FACILITY AMENDMENT CLASSIFICATION - DOCKET NO(S). 50-261

Plant Name and Unit(s): ROBINSON 2

H. B. ROBINSON STEAM ELECTRIC PLANT, UNIT NO. 2
DOCKET NO. 50-261
LICENSE NO. DPR-23
ISOLATION VALVE SEAL WATER SYSTEM

ISOLATION VALVE SEAL WATER SYSTEM

FIGURE 1

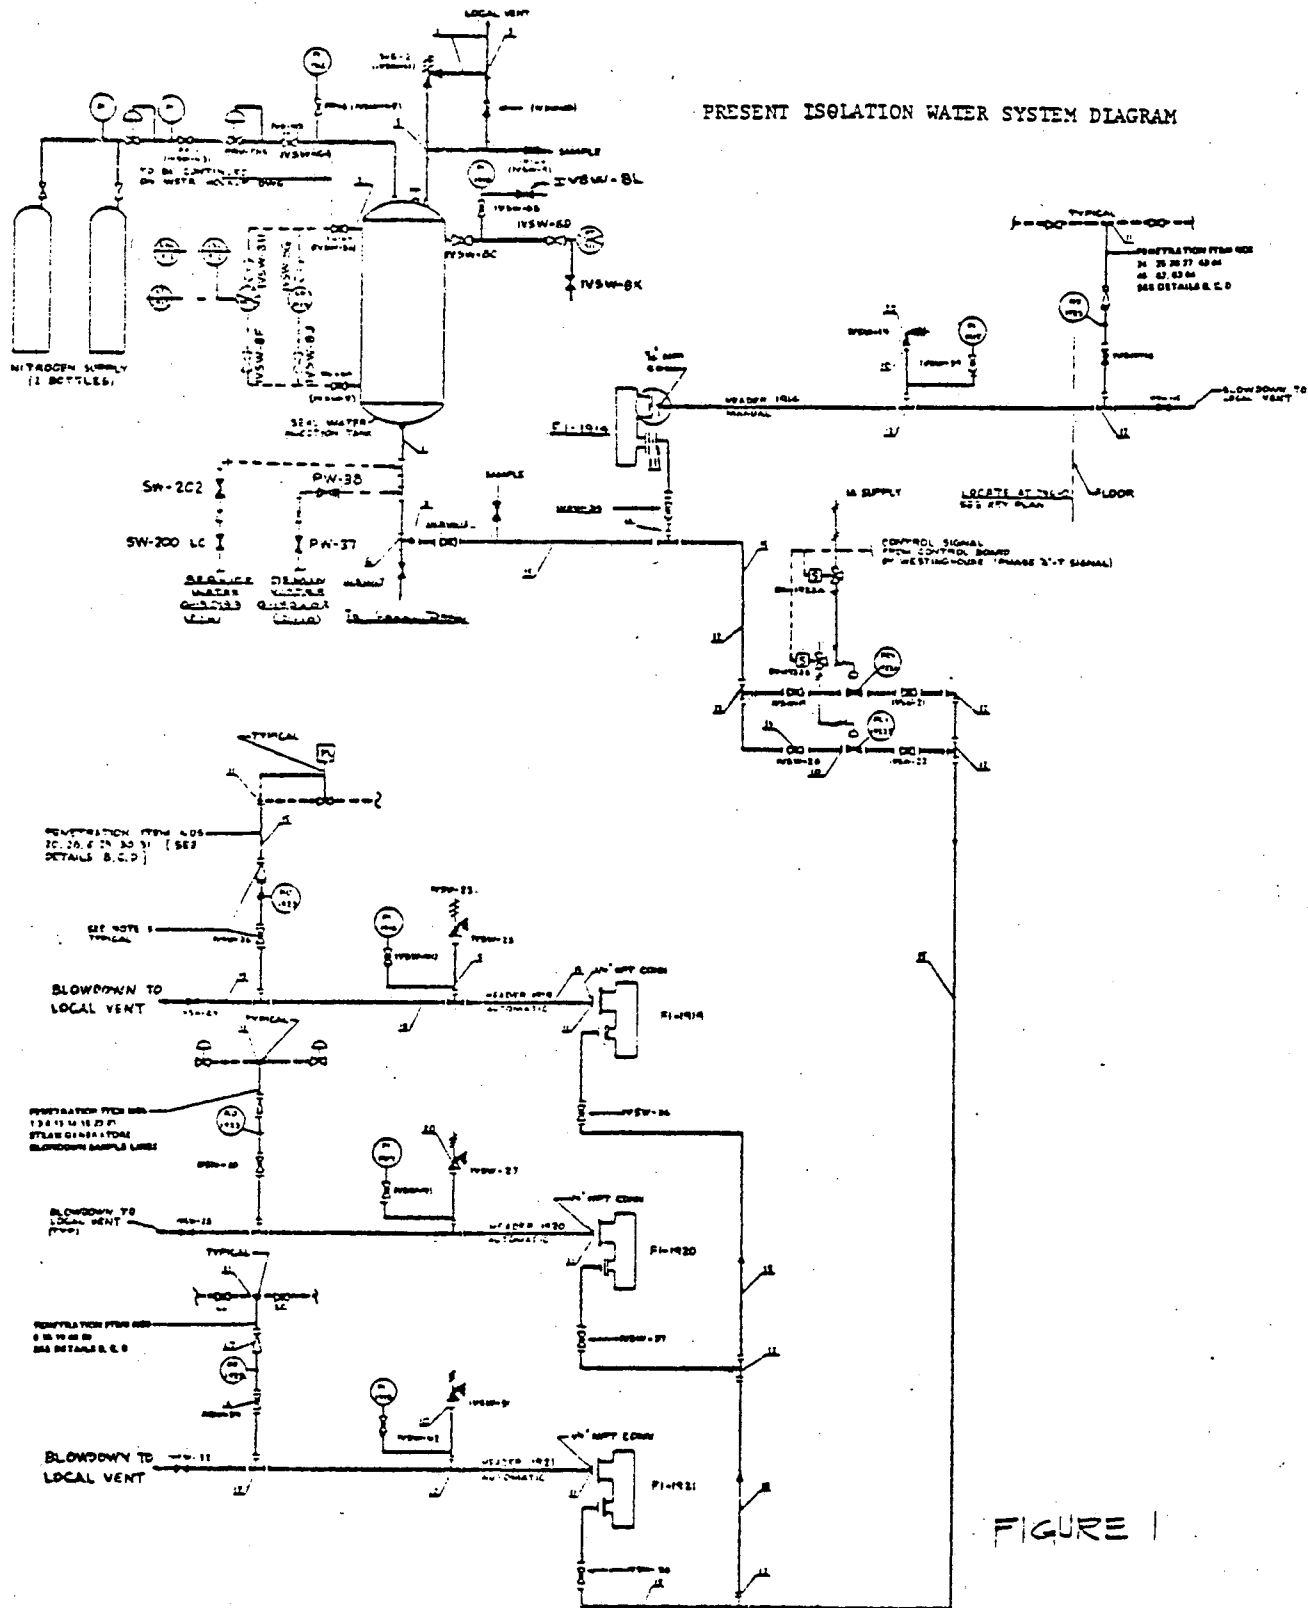
The present Isolation Valve Seal Water System flow diagram is shown in Figure 1. Changes to the system to increase its reliability are presented on Figure 2. These changes will be performed during the next refueling outage. Additional information is presented in Chapter 5 of the H. B. Robinson FSAR.

FIGURE 2

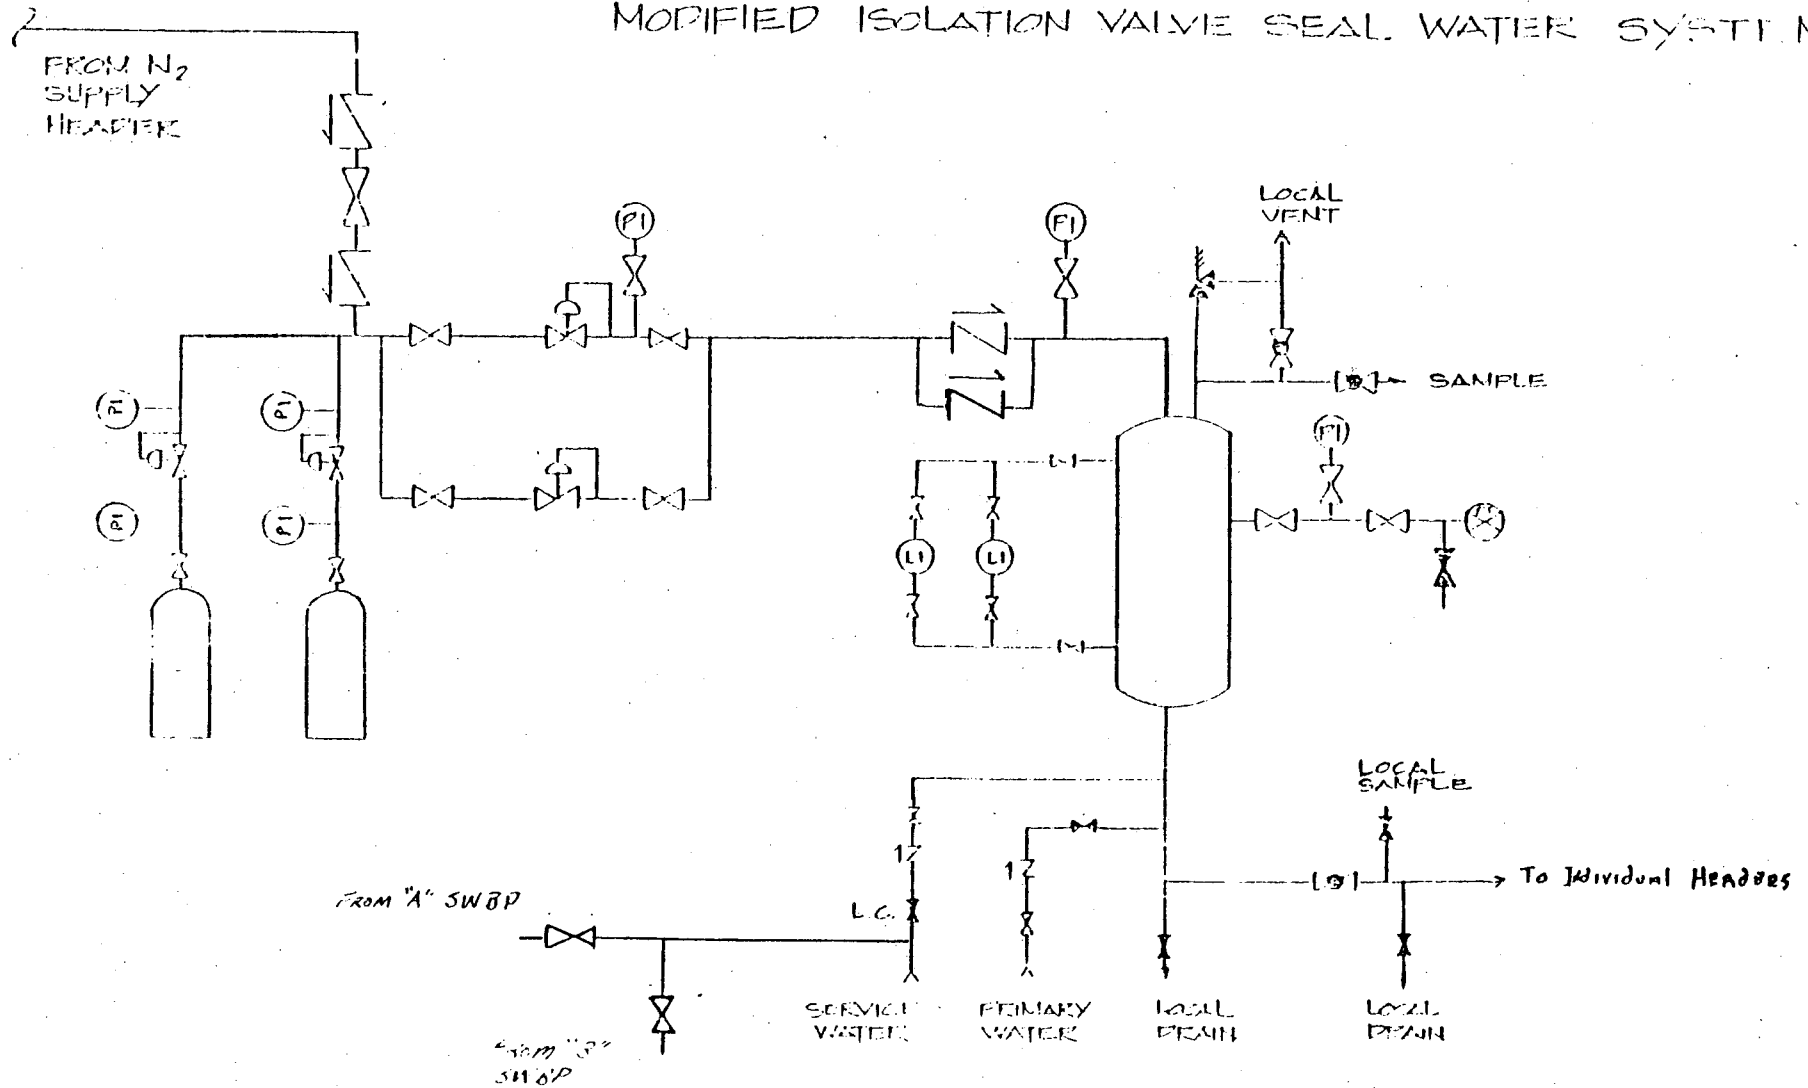
Attached to this letter is a description of the H. B. Robinson IVSW system. Our review over the last few months has indicated minor changes which will further enhance the reliability of the IVSW system. These changes will be made during the next refueling outage. Both the present and the proposed systems are shown in the attached figures (Figure 1 and Figure 2 respectively). These changes do not in any way constitute an unreviewed safety concern, and we are not asking for approval for the specific changes or credit for the seal functions of the system with regard to our dose calculations.
